Piper Aircraft, Inc.
2926 Piper Drive
Vero Beach, Florida, U.S.A. 32960

SERVICE BULLETIN

NO. 840A

FUEL SELECTOR VALVE COVER REPLACEMENT

Figure 1

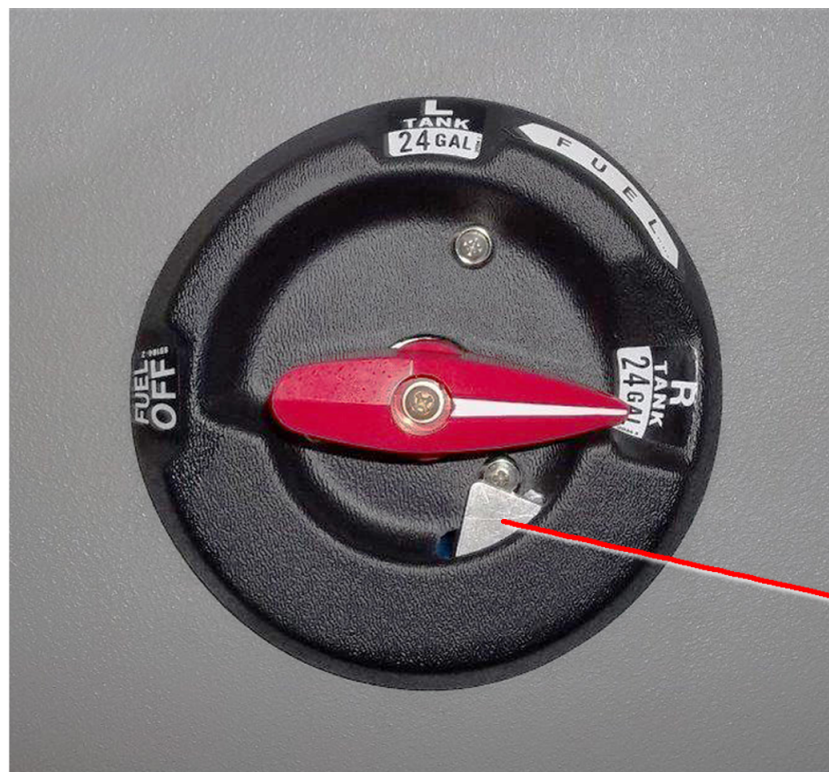
To announce the availability of a new fuel selector valve cover assembly and mating handle, which reduces the possibility of pilot mismanagement of the fuel system through inadvertent selection to the "OFF" position, resulting in power interruption or stoppage.

SPRING LOADED
METAL STOP, PROTRUDING
THROUGH AN OPENING
IN THE COVER

Kits 760-545 and 760-546, shown properly installed.

NOTE: Figure 1 shows proper installation of Piper Part Numbers 760-545 and 760-546. P/N 760-545 is similar to 760-546, except 760-545 includes additional parts and instructions to accommodate an adjacent cabin air vent (cabin air vent not shown in Figure 1).
